Allies & Ross Management and Development Corporation

IFB #2022-39

Plumbing Construction for the Manchester Redevelopment

ADDENDUM NO. #2

Supplemental Drawing No.1 Stone Foundation w/ Two-Part French Drain + Sump Pump
SCALE: 3/4" = 1'-0"

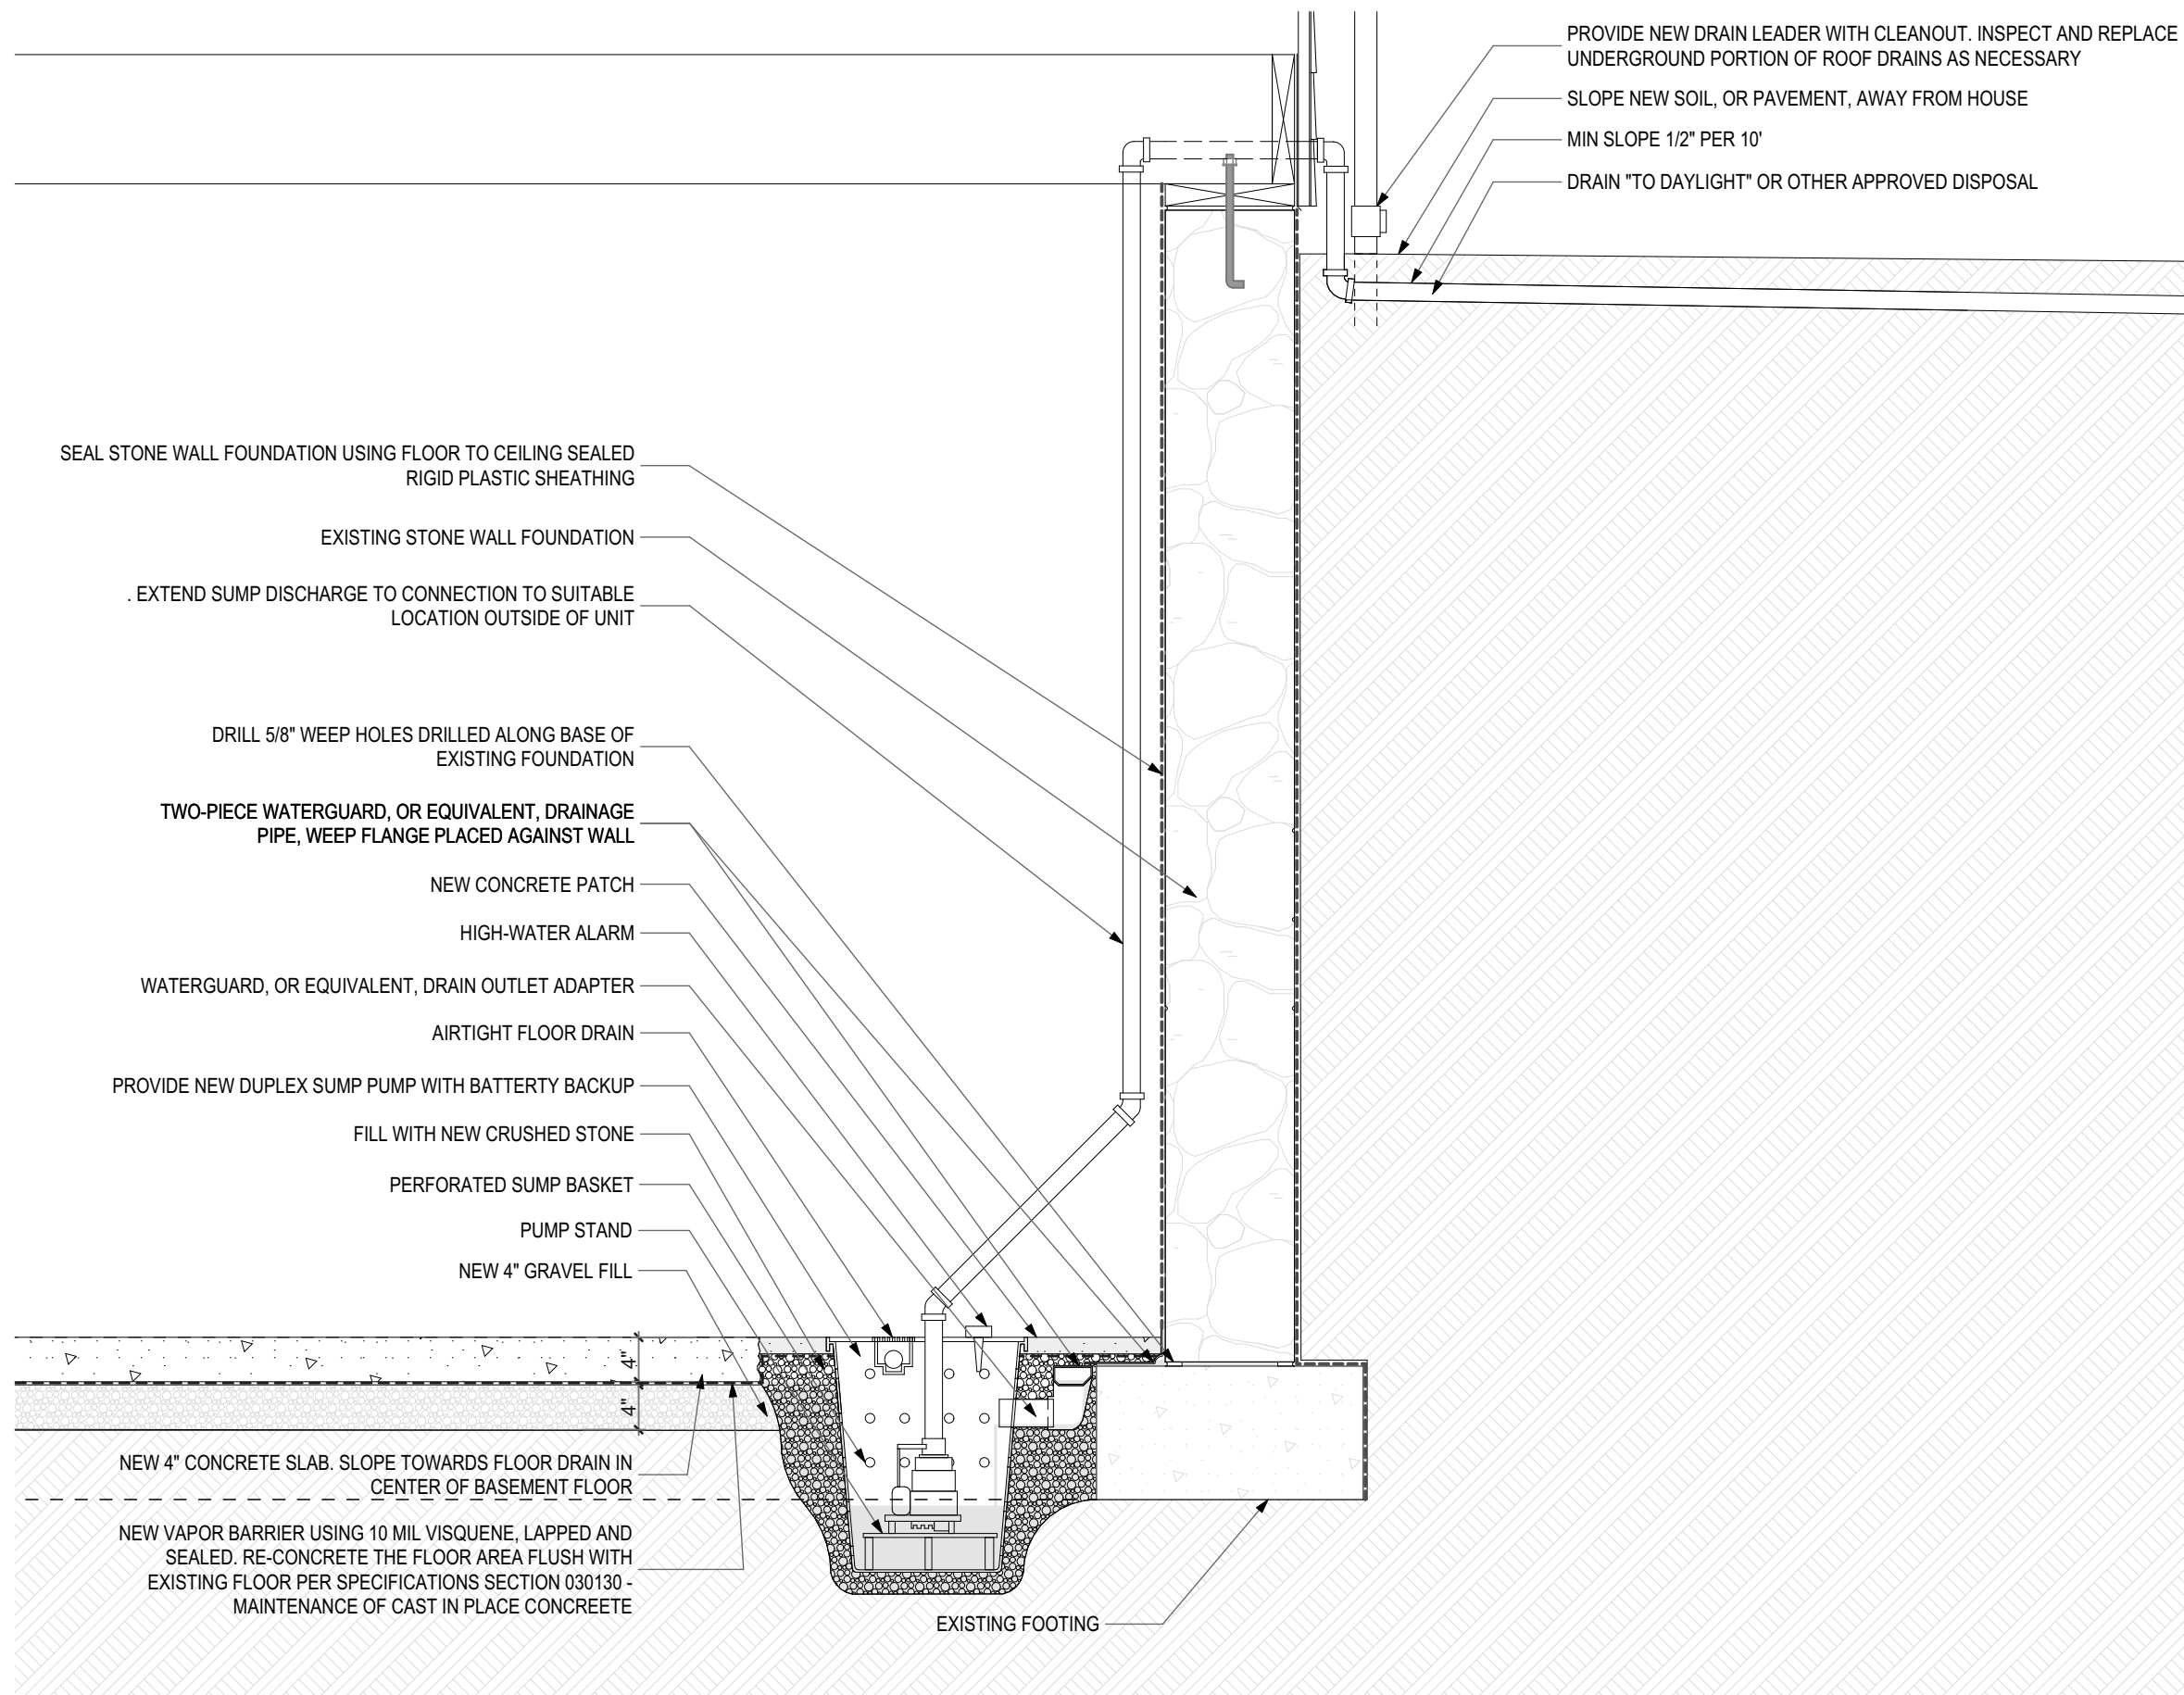
- **Can you please identify where this/these (addresses) are to be installed?**
- **In addition, can you please provide a detail indicating the requirements of this system (pipe size, connection point, fabric, stone requirements, etc.)?**

- **Can you please provide a detail of the requirements needed for the general contractor to perform their work? (Trench size, depth, width, etc)**
- **Can you please provide a detail of the wall prep required by the plumbing contractor for the general contractor to perform the dampproofing?**
- **The plumbing contractor would typically use a trench box to install the exterior foundation drainage system. Is the shoring to be engineered, and if so, can a**

Provide Instead: For the following three (3) properties install interior wall water vapor barrier and "WaterGuard", or equivalent, french drain system and sump pump per manufacturer's specifications. Refer to the Basement Damp Proofing supplementary section drawing No.1 "Stone Foundation w/ Two-Part French Drain + Sump Pump." Additionally, Plumbing Contractor shall be responsible for inspecting existing roof downspouts and underground drains. If drains are broken or compromised, Plumbing Contractor shall excavate to expose drain line and repair line so that it drains without obstruction to storm sewer system, using 4" Schedule 40 PVC or ABS pipe and installing new drain leader with cleanout at grade. In Plumbing Contractor's contract, Plumbing Contractor shall also provide cost to remove completely the existing basemen slab foundation, to remove 4" of soil and provide 4" of compacted gravel fill, 10 mil vapor barrier and new 4" concrete basement slab, sloped to sump drain.

1. Refer to SD1 Supplemental Drawing No.1 Stone Foundation w/ Two-Part French Drain + Sump Pump

- 1130 Sheffield Street, 1132 Sheffield Street and 1134 Sheffield Street
- Yes, please see the detail provided in Attachment A to this addendum.

- Yes. Also, it is the responsibility of the plumbing contractor to excavate, shore, and prep the exterior wall to receive the dampproofing according to Addendum No.1 IFB#2022-39 August 3, 2022.
- Yes, please see the detail provided in Attachment A to this addendum.
- Yes, please see the detail provided in Attachment A to this addendum.
- Yes.

Supplemental Drawing No.2 CMU Foundation w/ Two-Part French Drain + Sump Pump
SCALE: 3/4" = 1'-0"

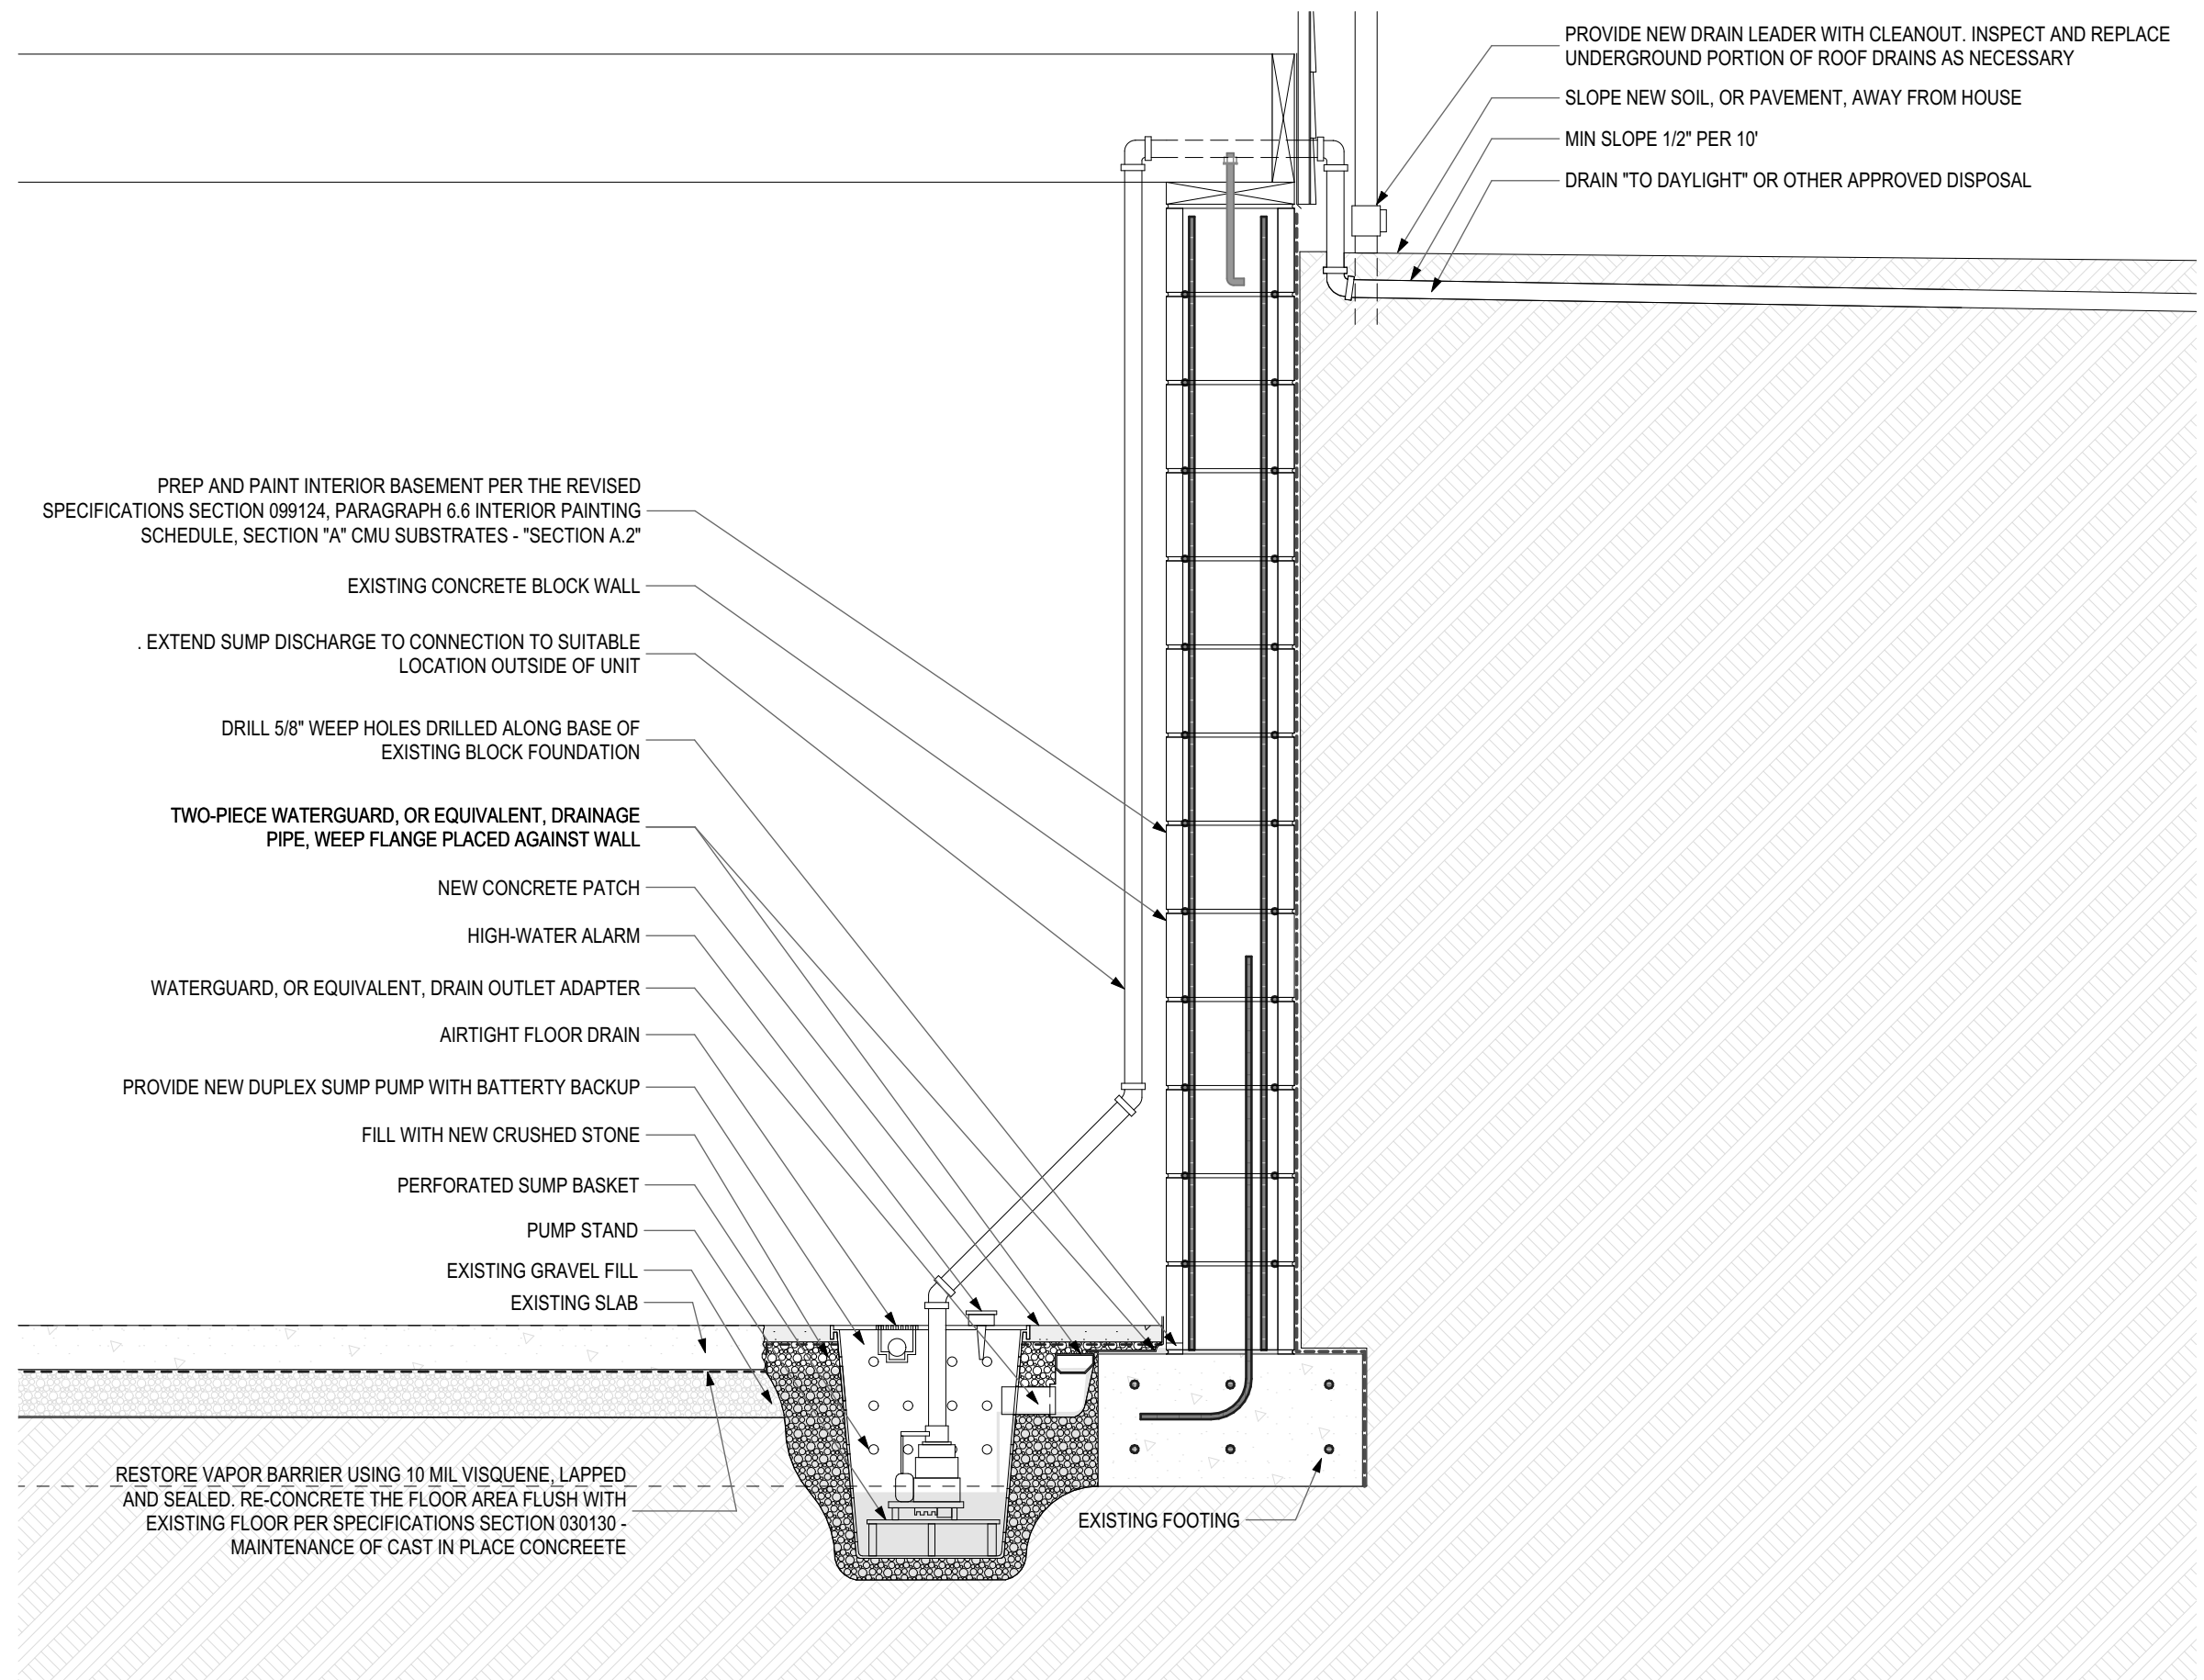
1. Supplemental Drawing No.2 CMU Foundation w/ Two-Part French Drain + Sump Pump
2. Supplemental Drawing No.3 CMU Foundation w/ Single French Drain + Sump Pump
